COMPLETE REVISION HISTORY TO THE 2015 I-CODES®

**Complete Revision History to the 2015 I-Codes: Successful Changes with
Public Comments: 2015 IRC**

First Printing: September 2014

FIGURE R301.2(4)A
ULTIMATE DESIGN WIND SPEEDS

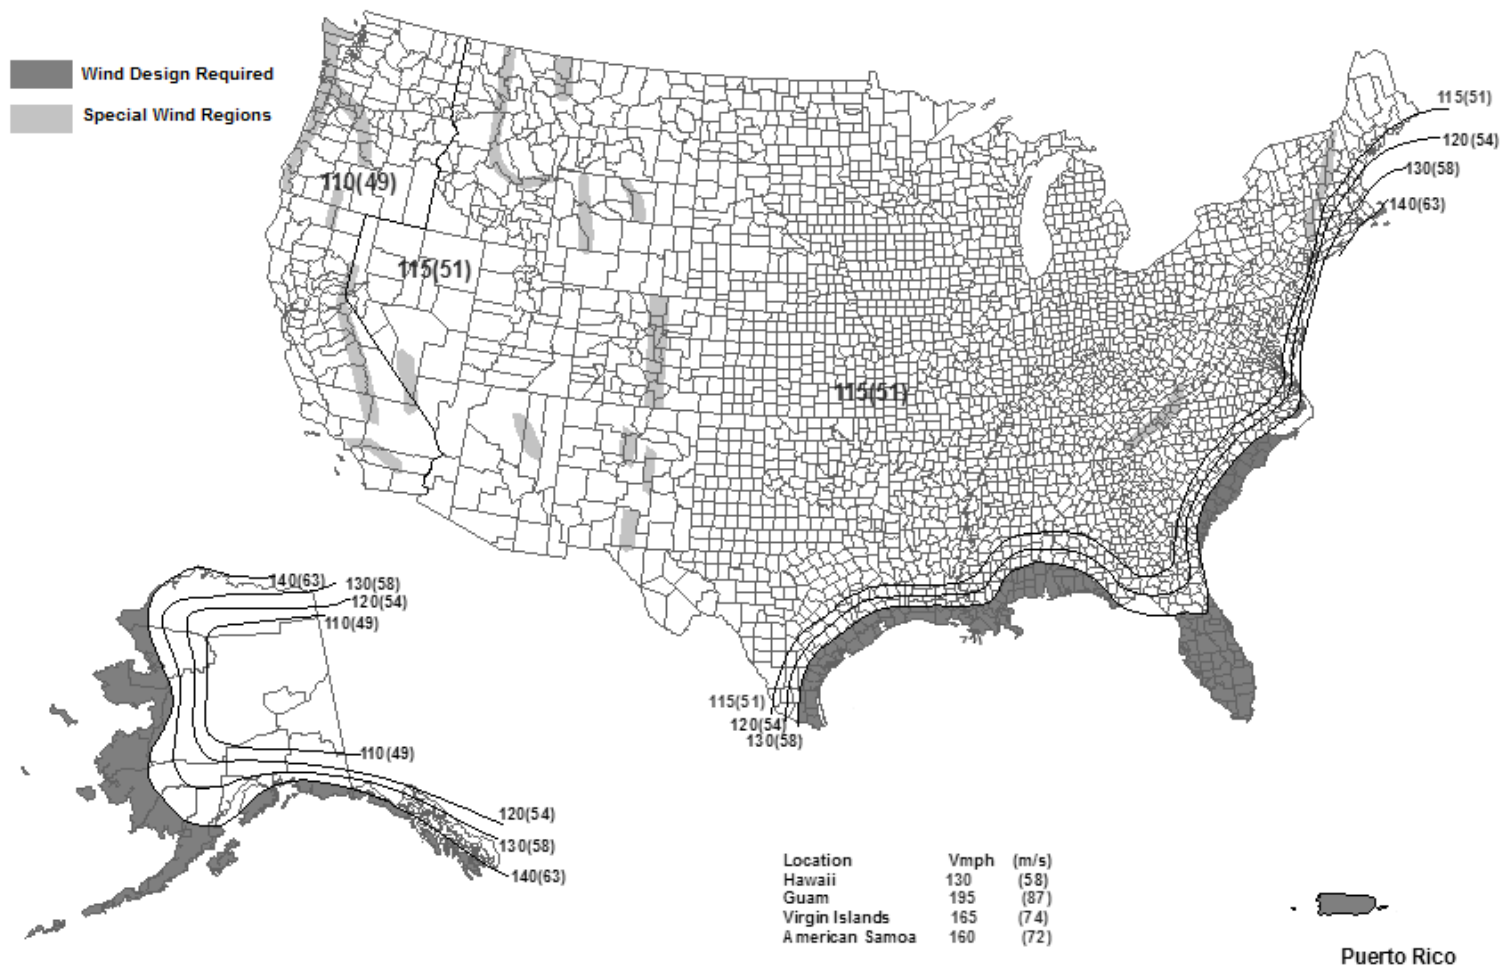
R301.2.1 Wind design criteria. Buildings and portions thereof shall be constructed in accordance with the wind provisions of this code using the ultimate design ~~basic~~ wind speed in Table R301.2(1) as determined from Figure R301.2(4)A. The structural provisions of this code for wind loads are not permitted where wind design is required as specified in Section R301.2.1.1. Where different construction methods and structural materials are used for various portions of a building, the applicable requirements of this section for each portion shall apply. Where not otherwise specified, the wind loads listed in Table R301.2(2) adjusted for height and exposure using Table R301.2(3) shall be used to determine design load performance requirements for wall coverings, curtain walls, roof coverings, exterior windows, skylights, garage doors and exterior doors. Asphalt shingles shall be designed for wind speeds in accordance with Section R905.2.4. A continuous load path shall be provided to transmit the applicable uplift forces in Section R802.11.1 from the roof assembly to the foundation.

R301.2.1.1 Wind limitations and wind design required. The wind provisions of this code shall not apply to the design of buildings where wind design is required in accordance with Figure R301.2(4)B ~~or where the basic wind speed from Figure R301.2(4)A equals or exceeds 110 miles per hour (49 m/s).~~

The region in revised Figure R301.2(4)B where the use of alternate prescriptive high-wind standards or engineered design is required is defined using the 130mph contour along the Gulf Coast and along the southern portions of the Atlantic coast from Florida up to North Carolina. The 140mph contour is used for the northern portions of the Atlantic coast from Virginia up to Maine, and for Alaska. A 130mph trigger is also used for the assorted Caribbean and Pacific islands that are also considered part of the "hurricane-prone" region. This creates a region that approximately equals the region defined by the 110mph contour under the wind map used in the 2000 through 2009 IRC, maintains areas of Florida and the Gulf Coast traditionally outside of the prescriptive limits of the IRC, and maintains areas of New England traditionally included within the prescriptive limits of the IRC.

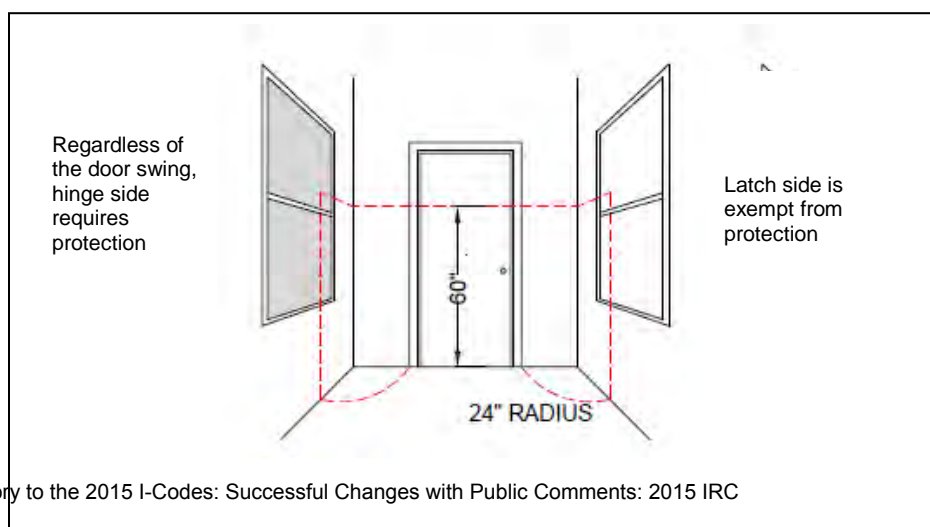
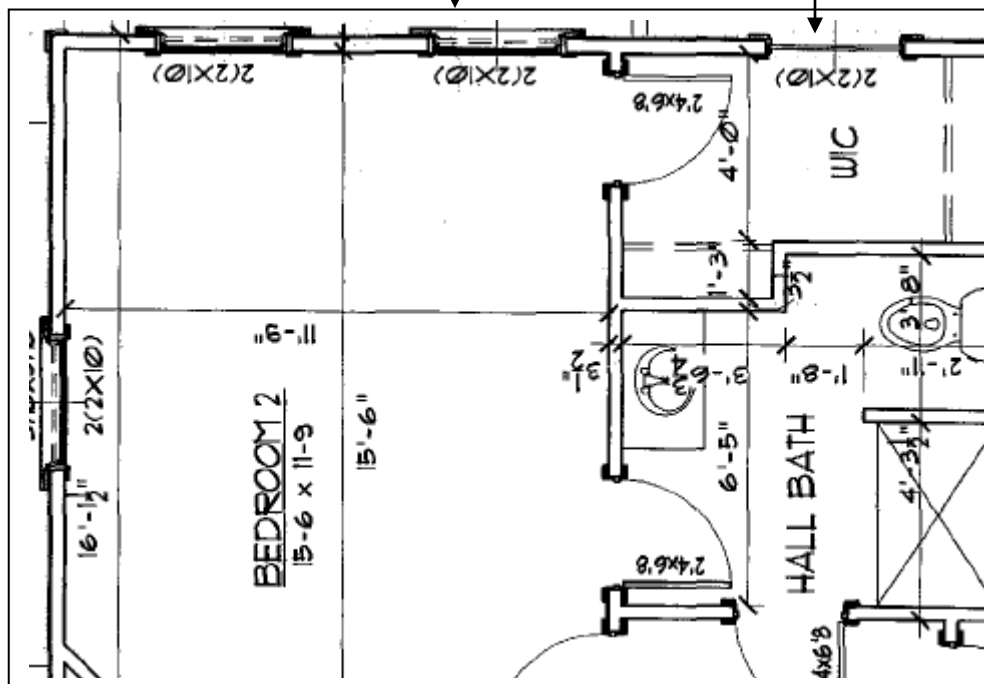
Exception 3: Currently the code requires safety glazing for windows on the hinge side of walls perpendicular to the door plane – regardless of the door swing. See sketch below.

Currently this window is NOT exempt by rule # 3 (or #4) and would have to be safety glazed. If this proposal is accepted, this window would NOT have to be safety glazed.

This window is currently exempt because the arc is more the 24" from the door hinge.

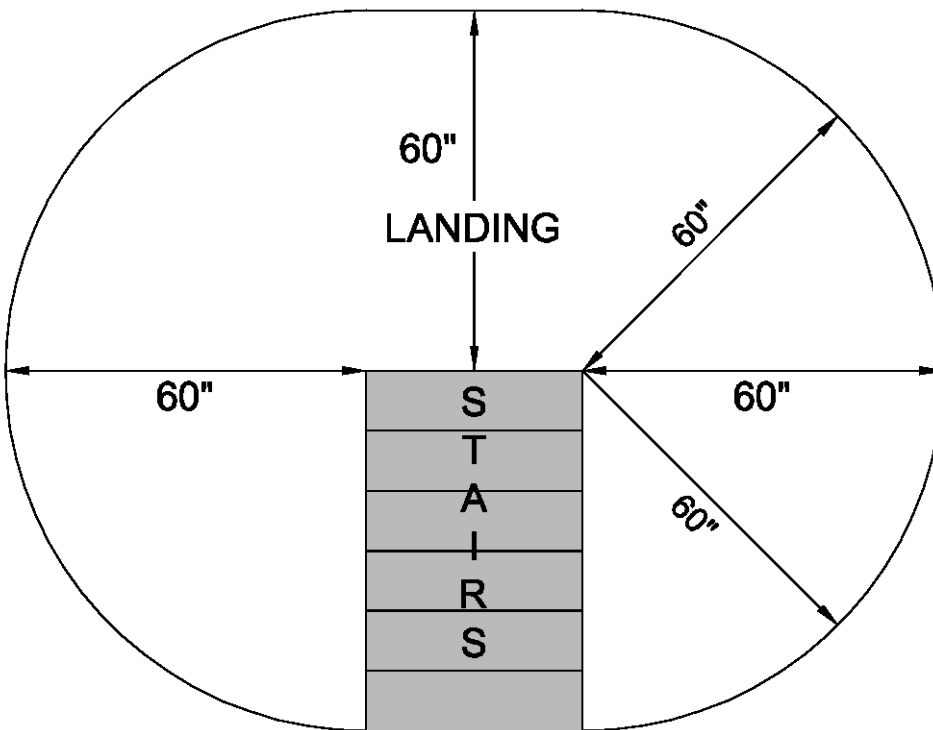
The new code language will incorporate the areas shown in the following diagram:

Figure R308.4.7

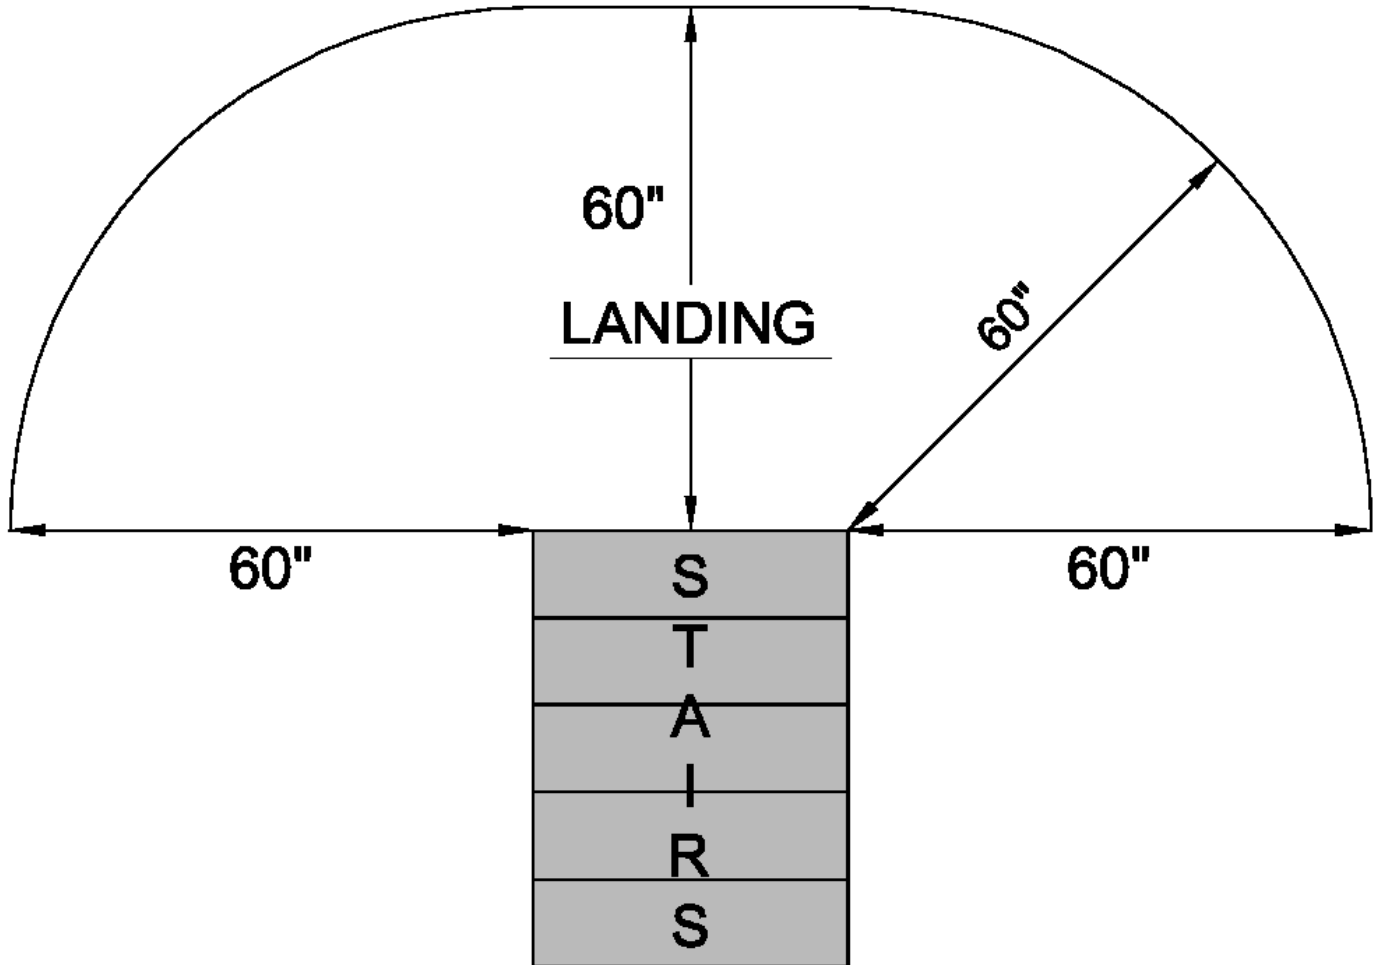
R308.4.7 Glazing adjacent to the bottom stair landing. Glazing adjacent to the landing at the bottom of a stairway where the glazing is less than 36 inches (914 mm) above the landing and within a 60 inches (1524 mm) horizontally of horizontal arc less than 180 degrees from the bottom tread nosing shall be considered a hazardous location.

Add the following figure to the proposal:

Figure 1 Residential Range = 7.58" (193mm) – 7.74" (197mm), Commercial Range = 6.84" (174mm) – 7" (178mm) see Table 1
Please note that the described circled ranges have been added to figures 1&2 by the proponent for the purpose of explanation.

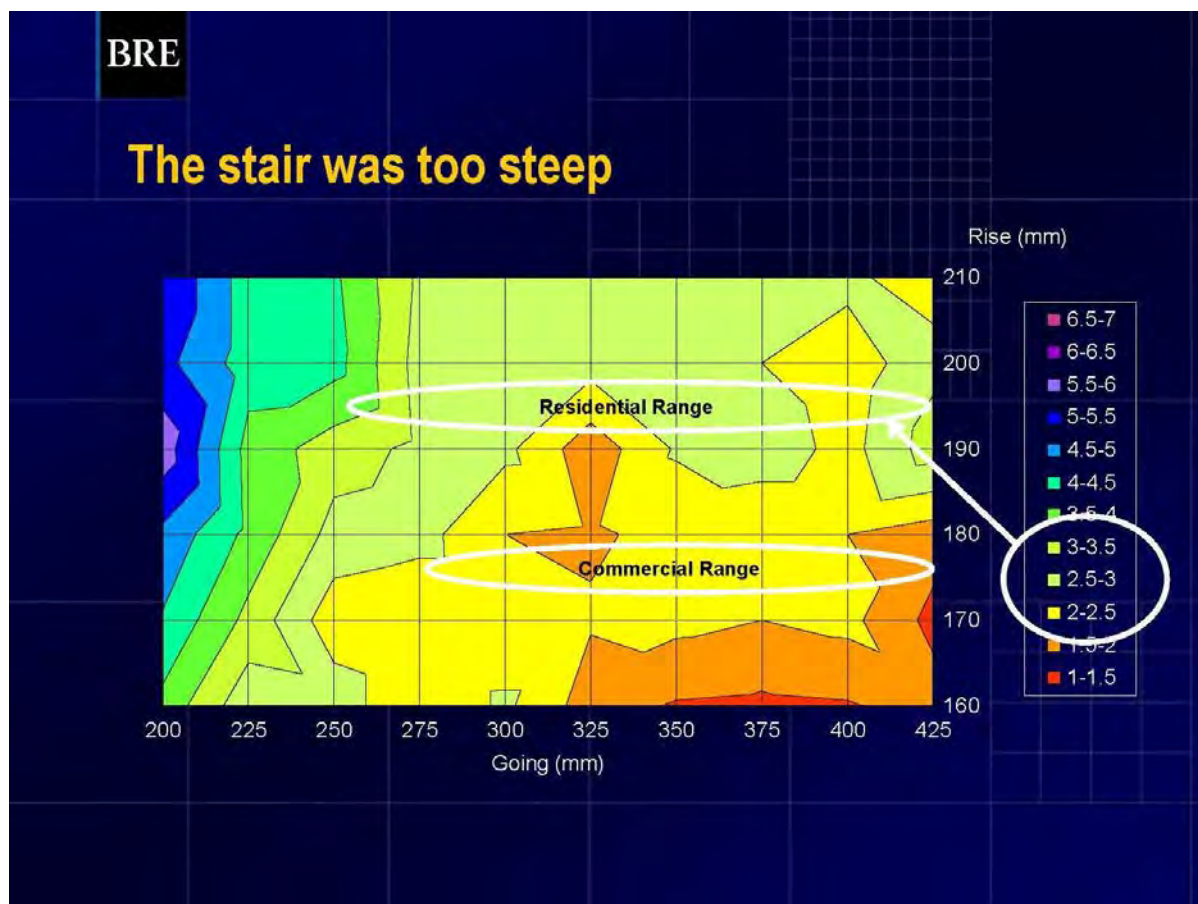
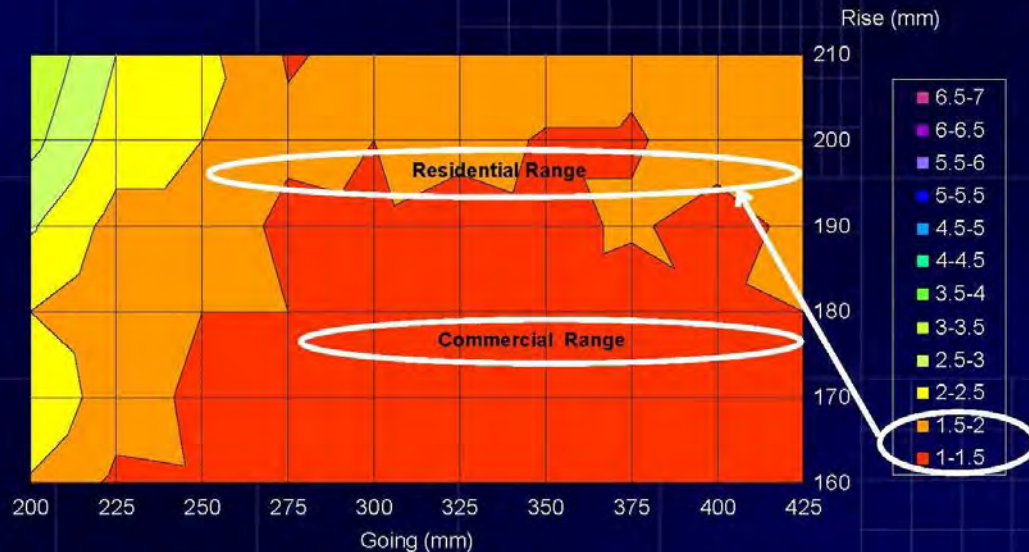
Reason: The elevation of 147 inches is a multiple of the maximum riser height of 7-3/4 inches (197 mm). (See Table 1) This minor change of just 3 inches (76 mm) in the total rise of the flight would in many cases eliminate the cost of incorporating a landing and the space required, reducing construction costs. As can be seen in the table below this change would require no additional steps in the stair than the current code requires and a change in riser height of just 5/32 inch (4 mm) or less when the minimum number of risers is desired. This represents no discernable difference consequential to the user.

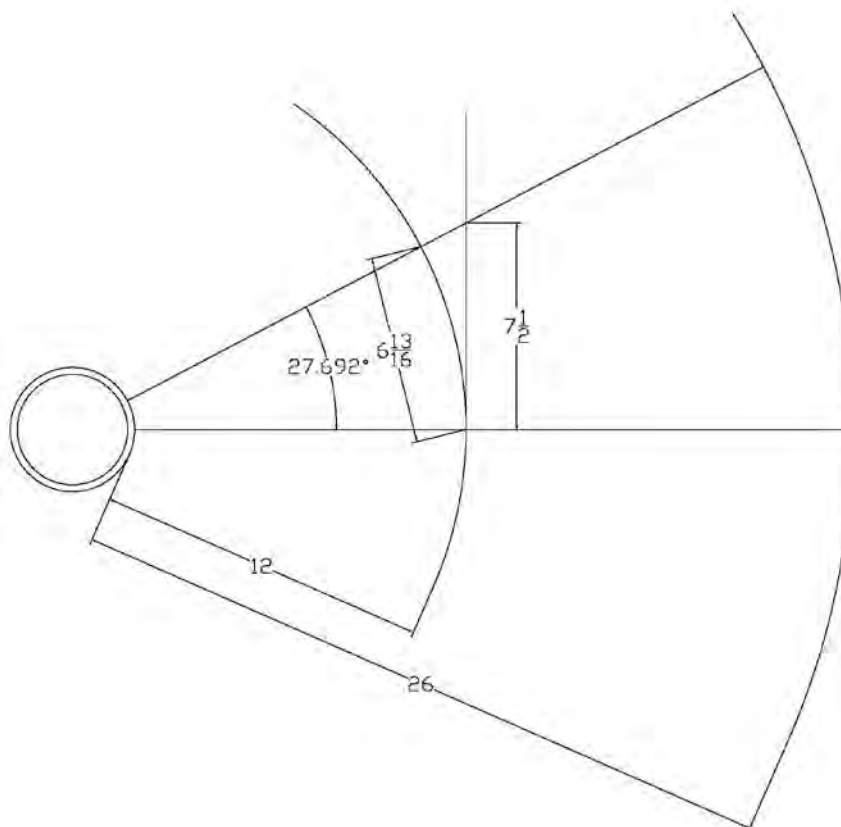
FIGURE ONE illustrates a winder tread from a typical spiral stairway with 13 treads per revolution. The dimensions shown allow comparison of the tread depth when measured square to the leading edge and when measured at the intersection of the walkline with the nosings. This simply shows that the old requirement of 7½ inches needs to change to accommodate the new measuring method cited in **R311.7.5.2.1 Winder Treads**.

FIGURE R403.1(1)
PLAIN CONCRETE FOOTINGS AND MASONRY AND CONCRETE STEMWALLS ON IN SDC A, B AND C D0, D1 AND D2
a,b,c,d,e,f,g

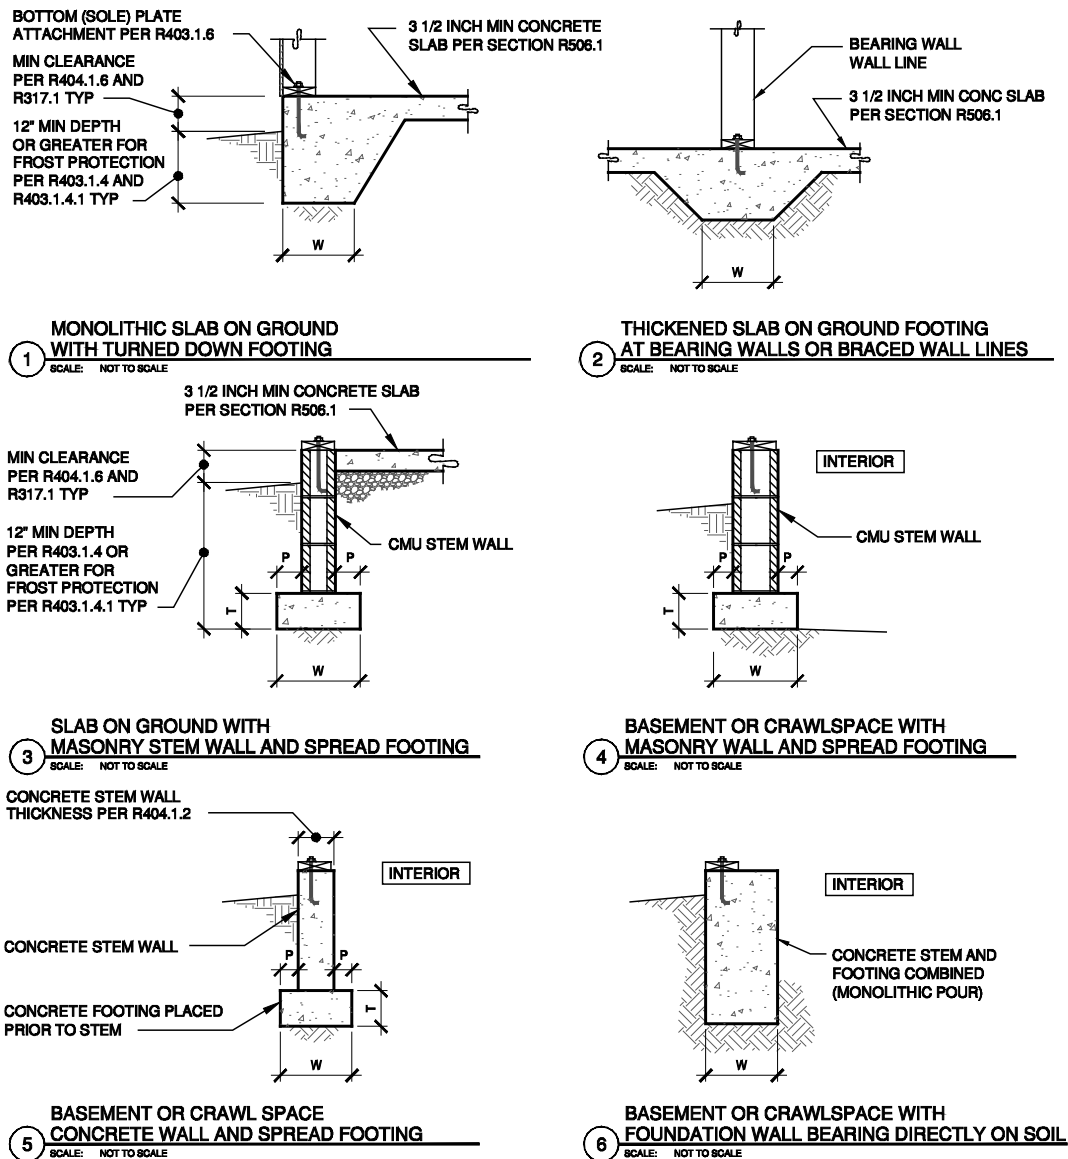
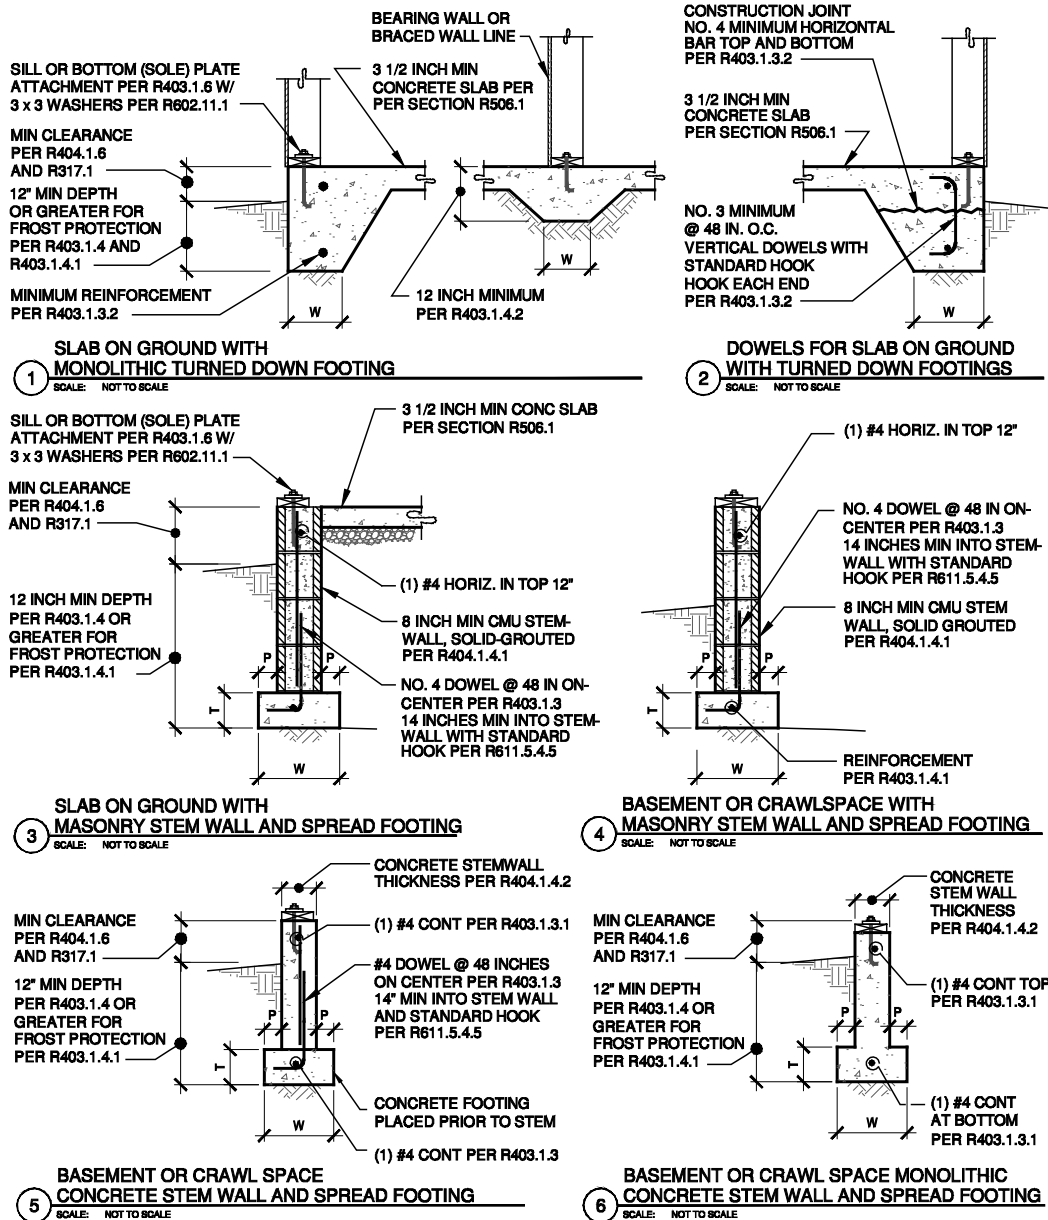
Charles S. Bajnai, Chesterfield County, VA, representing ICC Building Code Action Committee, requests Approval as Modified by this Public Comment.
